AR-07-0401

Southern Nuclear Operating Company
Vogtle Early Site Permit Application
Response to Requests for Additional Information Letter No. 3

Response to February 16, 2007 RAI Letter No. 3

Figure 2.1-10 10 to 50-Mile Resident Population Distribution 2000

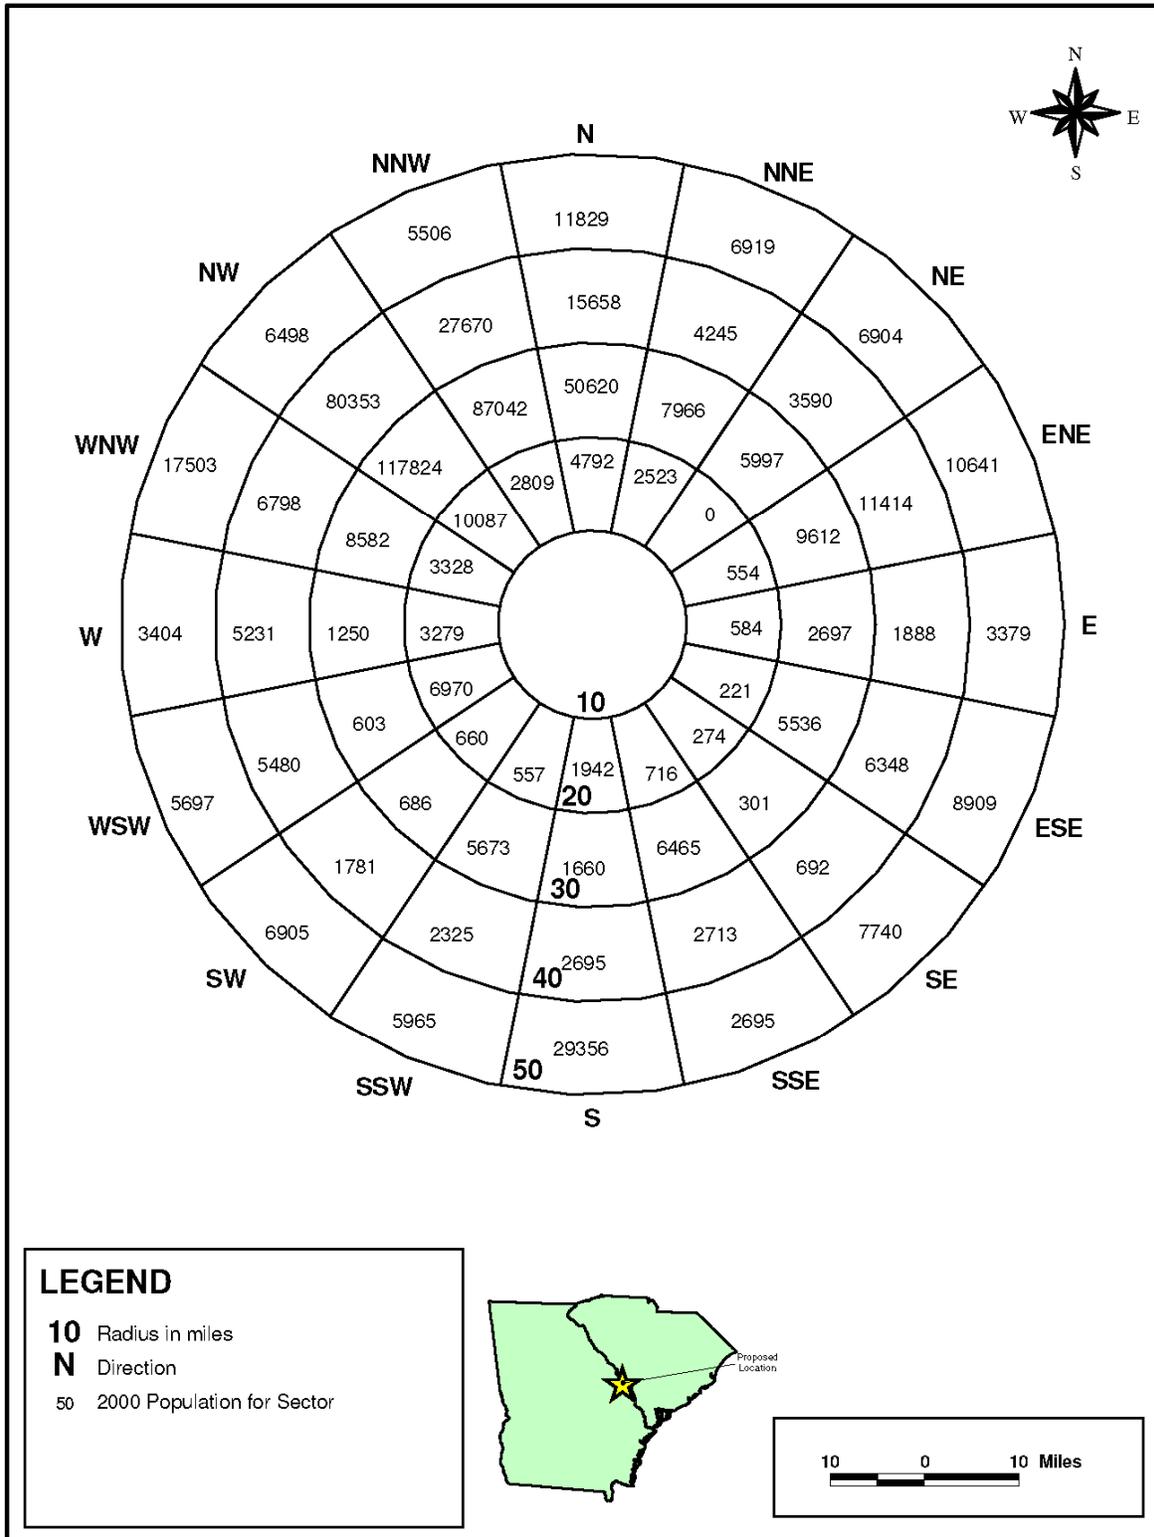
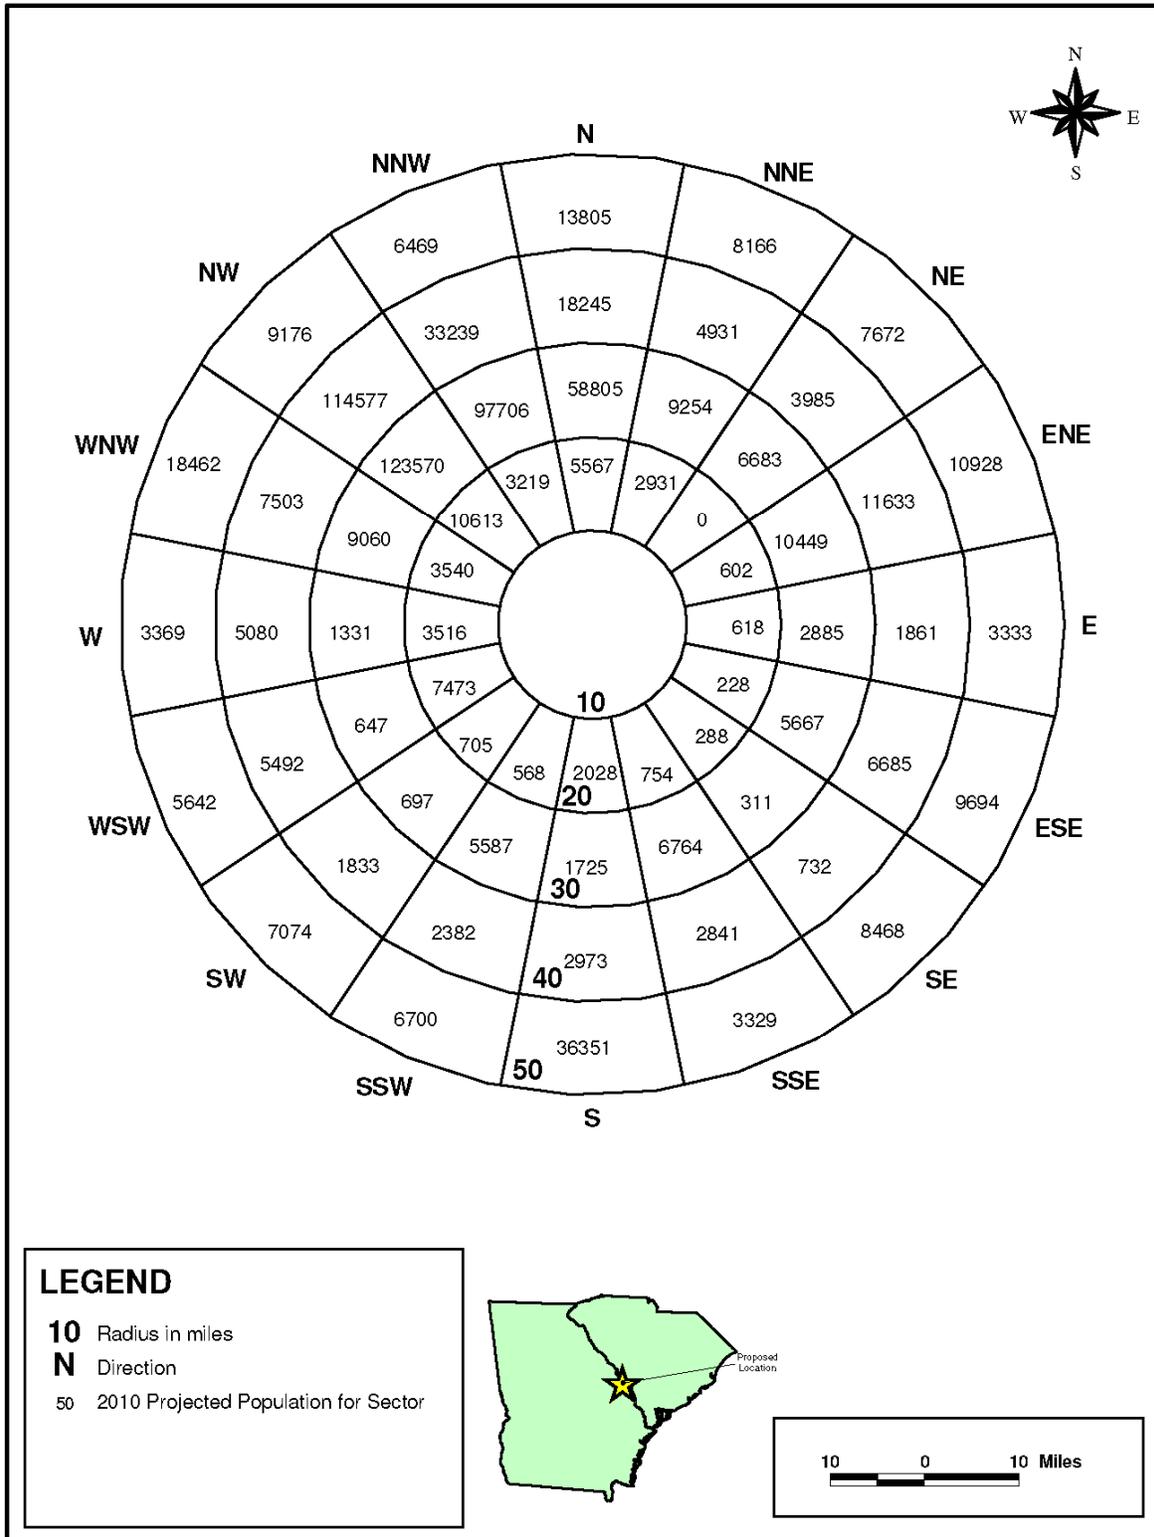
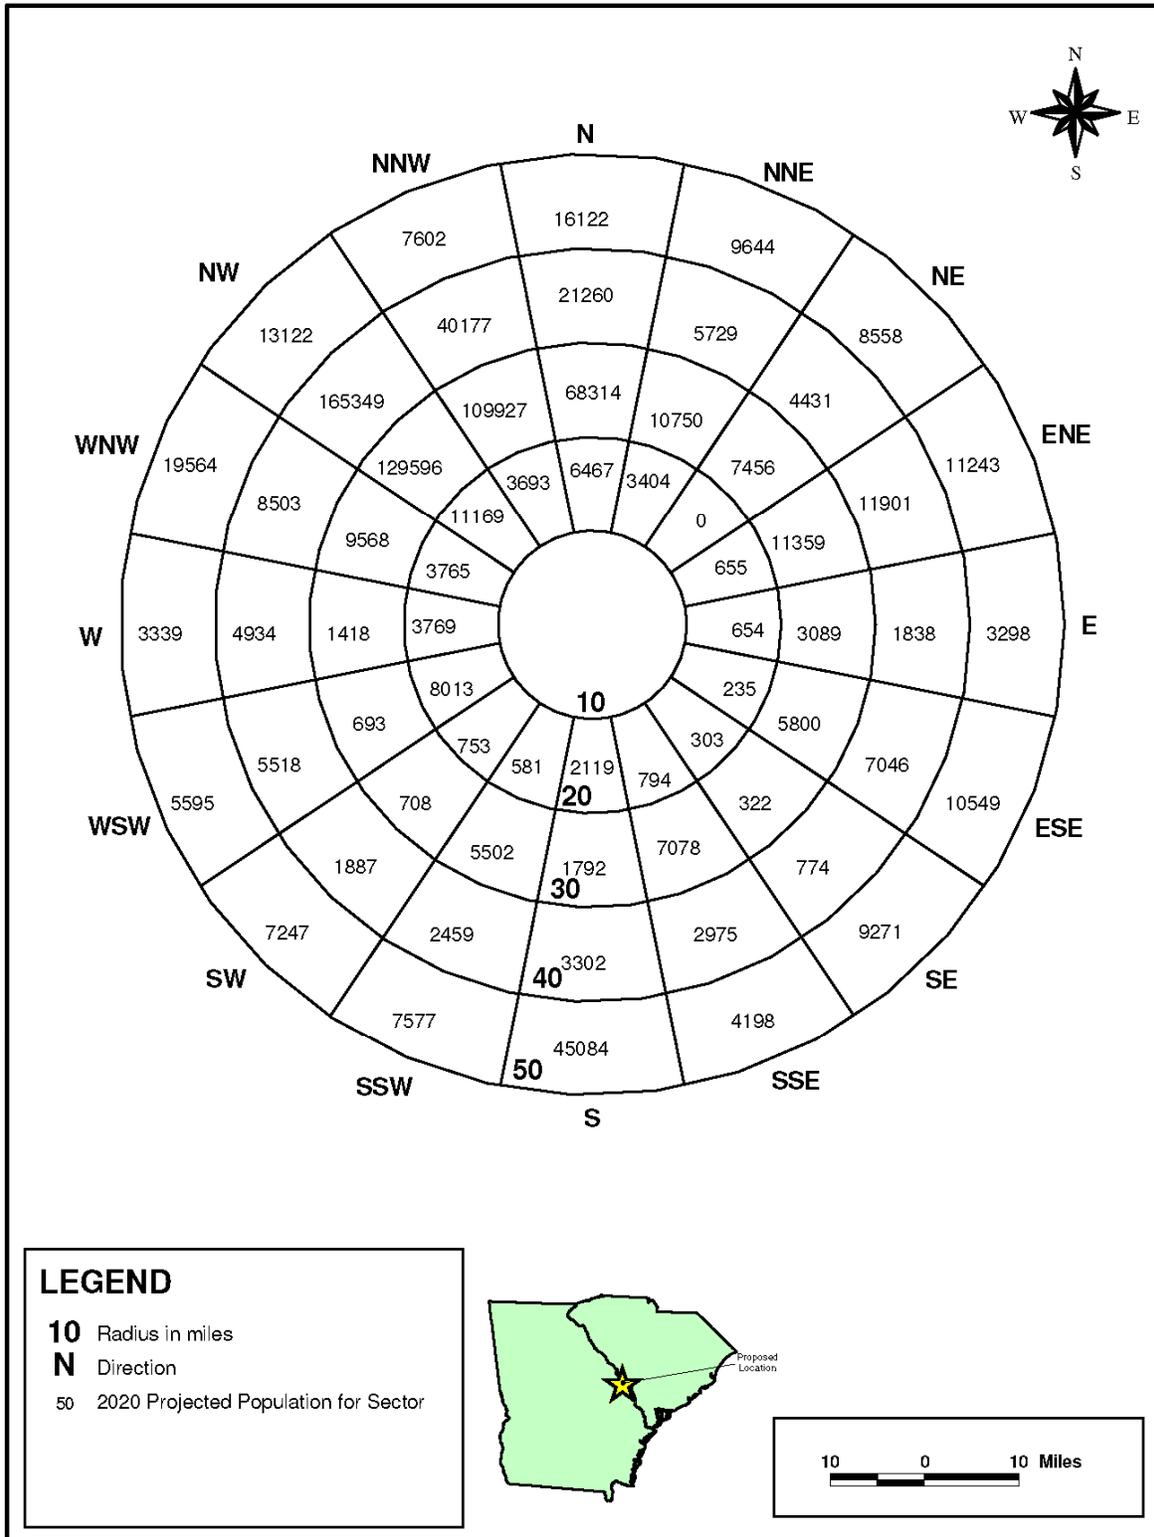
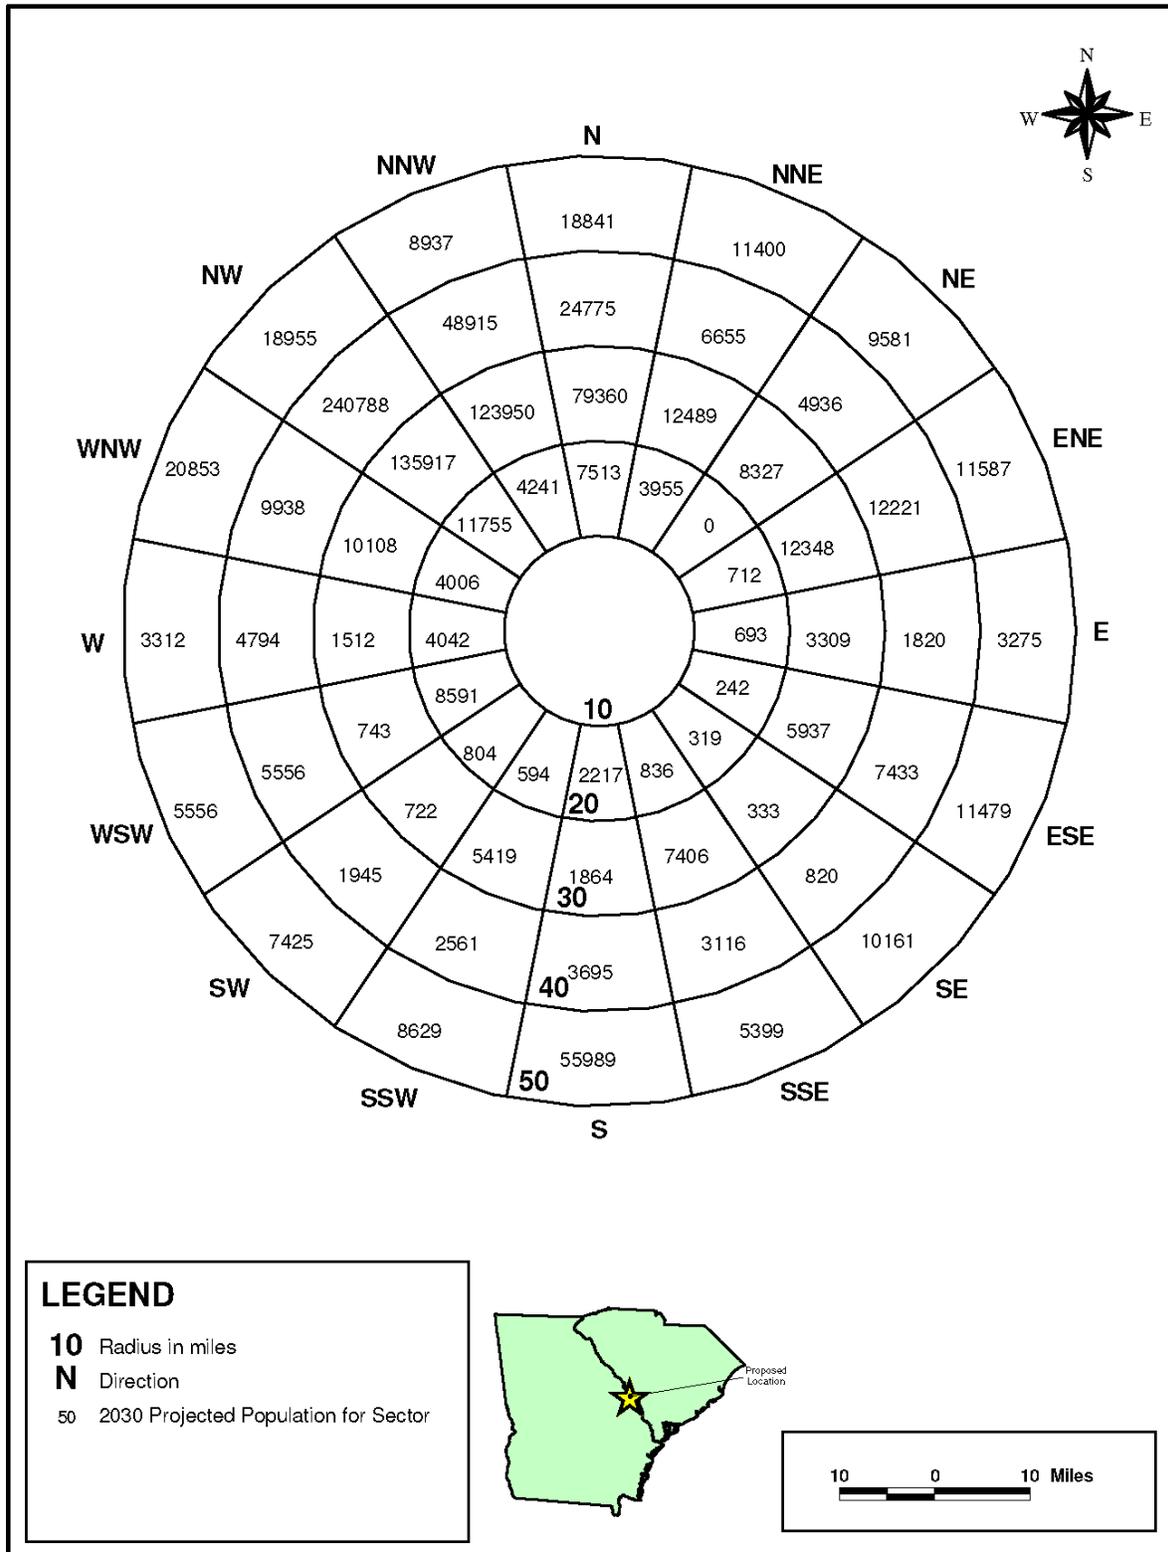
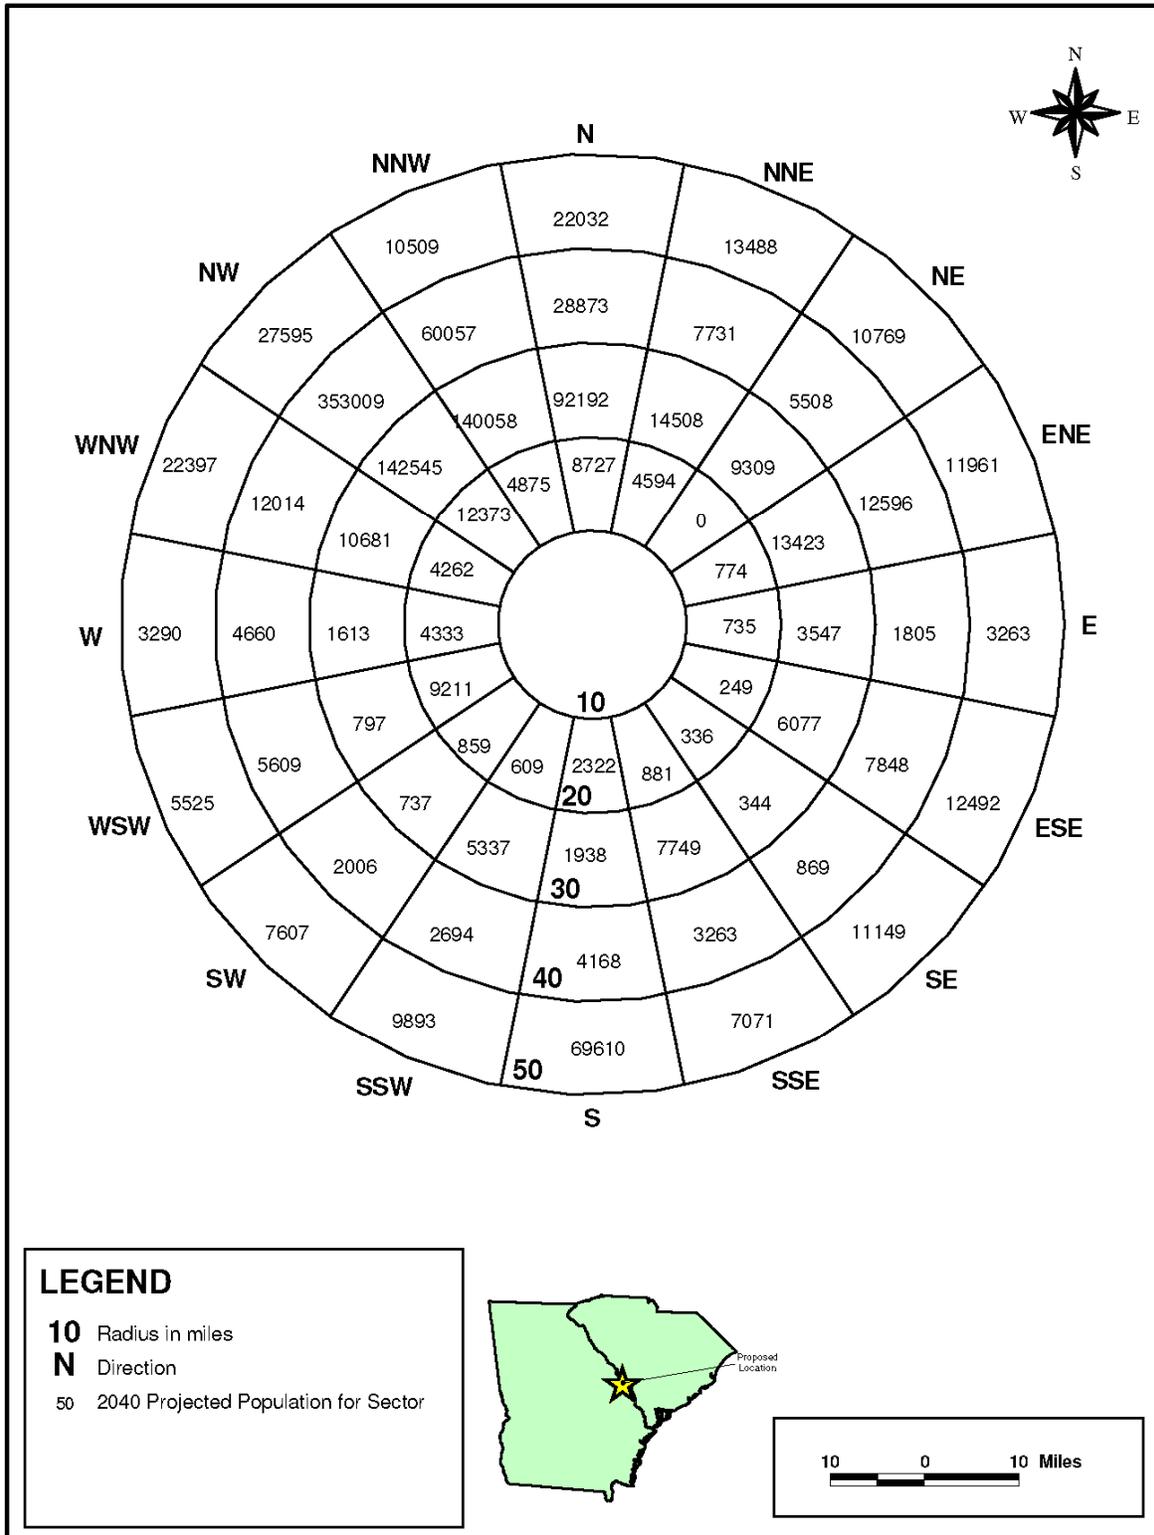
2.1.3-2 In Section 2.1.3, Figures 2.1-10 through 2.1-15 contain population distributions from 10-50 miles (population within 10 miles is not included), but the figures are labeled as 50-mile Resident Population Distribution, thereby implying that the population distribution presented is from 0-50 miles. Please change the title of the figures to represent the 10-50 miles Resident Population Distribution.

The titles for Figures 2.1-10 through 2.1-15 have been revised to show them as 10 – 50 Mile Resident Population Distribution. These revised Figures are included in Enclosure 2.
